DEVELOPMENT CONSENT AUTHORITY DARWIN DIVISION

AGENDA ITEM: 2	MEETING DATE: 21/08/2026	FILE: PA2026/0094
APPLICATION PURPOSE	RECONSIDERATION - Additions to an existing dwelling-single with a reduced building setback to the primary street and side boundaries	
SUBJECT SITE:	Lot 5818 (96) Cullen Bay Cres, Larrakeyah, Town of Darwin	
ZONE:	LR (Low Density Residential)	
SITE AREA:	1160m ²	
APPLICANT	Sheridan Consulting Director - Joseph Sheridan	
PERSONS ON WHOSE BEHALF THE APPLICATION IS MADE	Landowner	
LANDOWNER	Vanessa Marie Farmer	
ANY PERSON WITH AN AGREEMENT TO ACQUIRE AN INTEREST IN THE LAND	John Da Costa

Figure 1: Proposed and Amended Site Plans

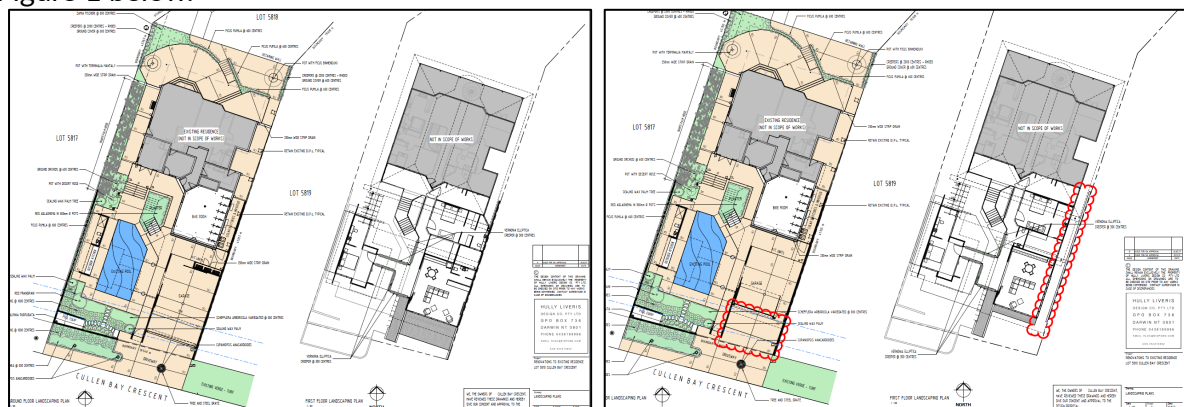
The primary street frontage setback of the proposed ground-floor garage has been increased to a minimum of 4.5m however, it is noted that the garage roof, the first-floor eave, and privacy slat screen setback at 3.64m, 3.6m, and 3.75m respectively, encroaching within 0.9m into the minimum setback of 4.5m.

The eastern side setbacks have been increased from 0m to a minimum of 1.42m in accordance with the existing dwelling at the rear portion of the site, which responds to Requirement (b) of the Letter of Deferral. Except for 1.42m setback for the garage supporting column, the rest of the proposed building has a minimum eastern side setback at more than 1.5m, which complies with the provisions of Clause 5.4.3 (Building Setbacks of Residential Buildings and Ancillary Structures) and does not require consent.

Drawing ROOF PLAN		
Scale 1 : 50	Drawn JT	Date 26.06.22
Cad File	Sheet no. A10	Issue C

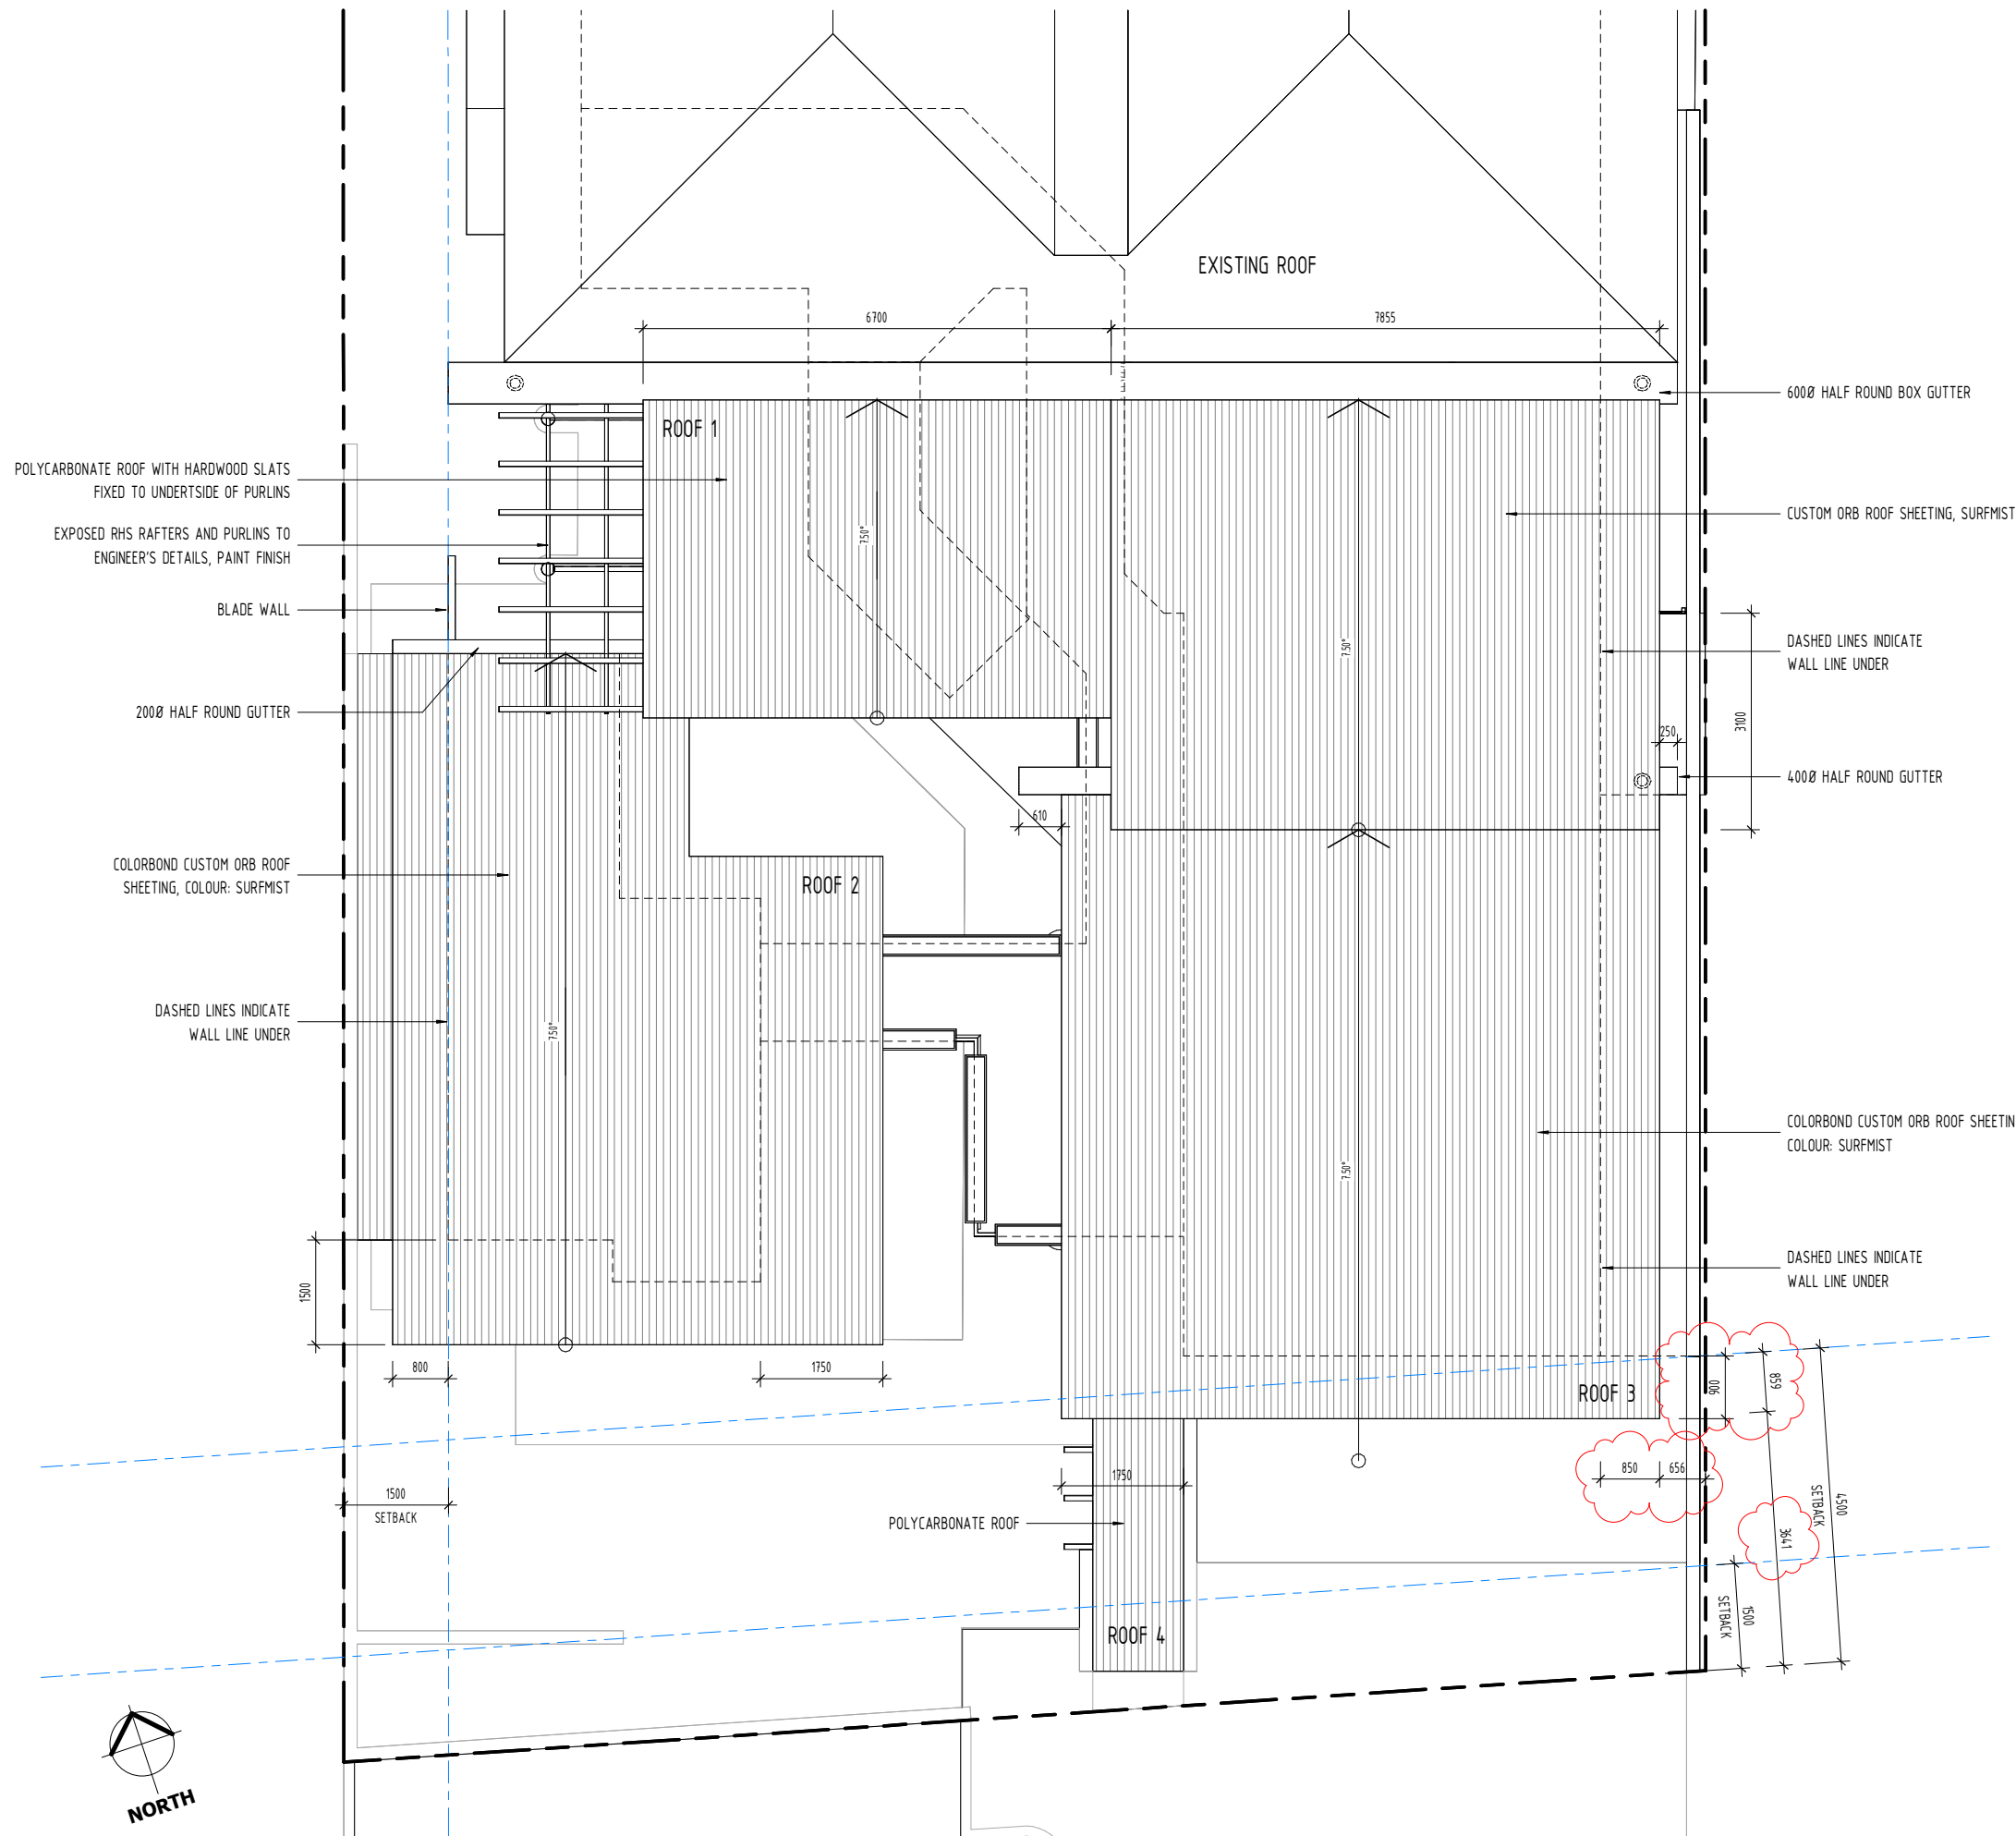
The ground floor and first-floor setbacks for the eaves are also consistent with the existing dwelling at 850mm thus complying with NTPS setback requirements. This also allows the required guttering and downpipes to achieve a consistent setback for the eaves and overall roof design of the existing dwelling (see sheet A10 at **Attachment B**).

Figure 1: Area A and Area B of the private open space

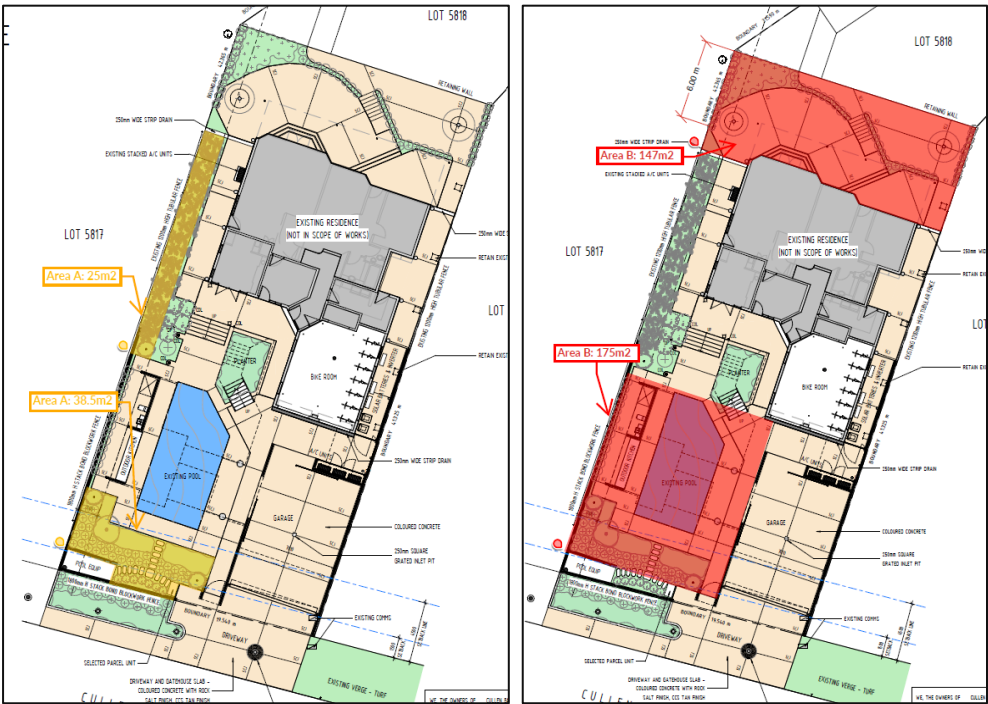
It is noted that the clause requires that at least half of Area A must be permeable, and may include the 5m² required for deep soil planting. The proposed Area A has an area of 63.5 m² and is wholly permeable, making it suitable for deep soil planting. Refer to Figure 1 below.
